DEVELOPMENT APPLICATION ASSESSMENT REPORT

Application Number:	DA2018/1995
----------------------------	-------------

Responsible Officer:	Renee Ezzy
Land to be developed (Address):	Lot 9 DP 629464, 104 Cabarita Road AVALON BEACH NSW 2107 Lot 8 DP 629464, 102 Cabarita Road AVALON BEACH NSW 2107 Lot 15 DP 858130, 100 Cabarita Road AVALON BEACH NSW 2107 Lot 14 DP 858130, 96 Cabarita Road AVALON BEACH NSW 2107
Proposed Development:	Construction of a dwelling house on lot 8 of proposed subdivision
Zoning:	E4 Environmental Living
Development Permissible:	Yes
Existing Use Rights:	No
Consent Authority:	Northern Beaches Council
Land and Environment Court Action:	No
Owner:	Basscave Pty Ltd Peter Gordon Higgins Rebecca Meta Higgins
Applicant:	Meraki Developments Pty Ltd

North-West Elevation - Side boundary envelope non-compliance (source: Mark Hurcum Architects)

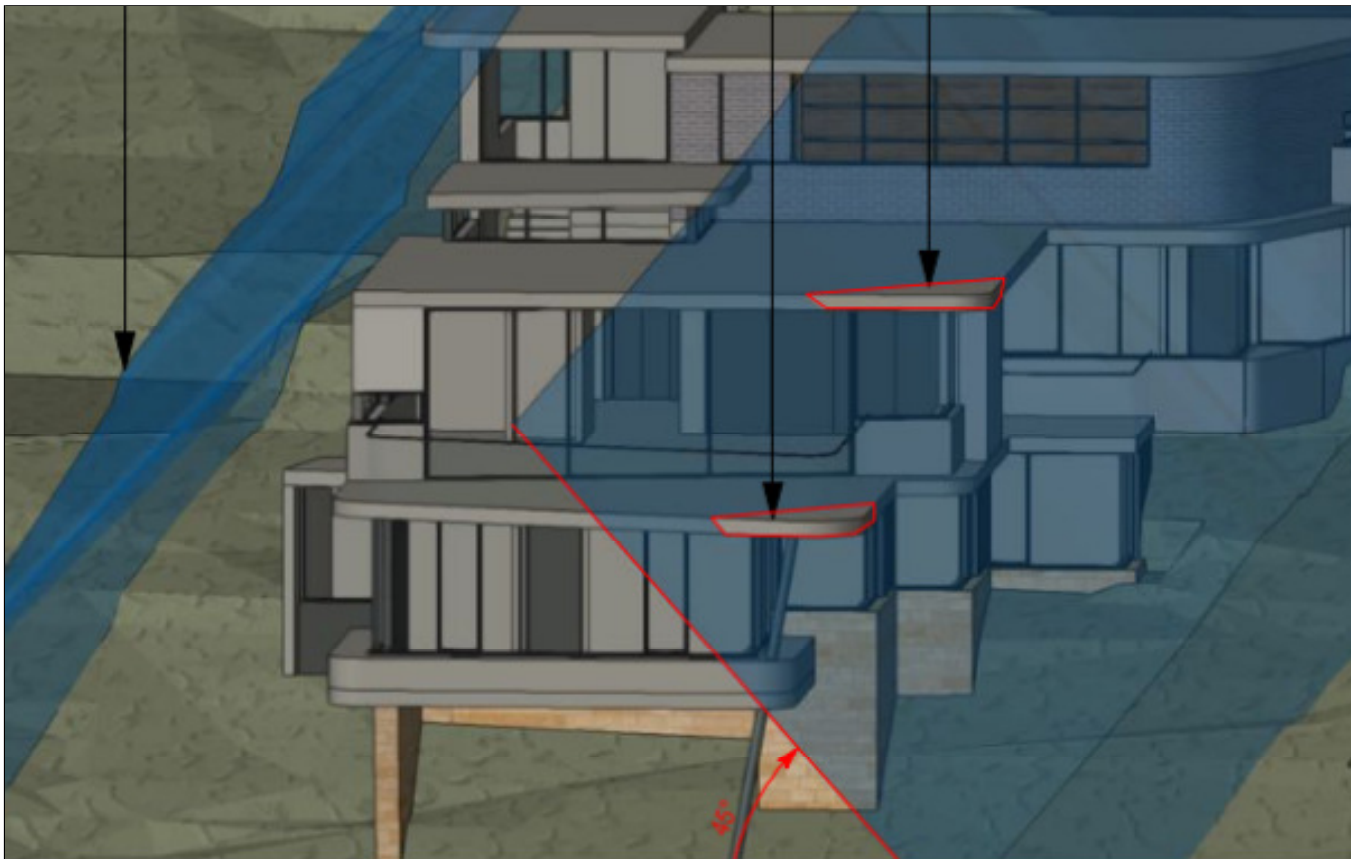
The proposed development results in a number of small non-compliances with the building envelope along the north-western elevation. Accordingly, the proposal is considered against the underlying Outcomes of the control.

As such, it is recommended that the proposal be supported on merit, despite the technical noncompliance with the building envelope control.
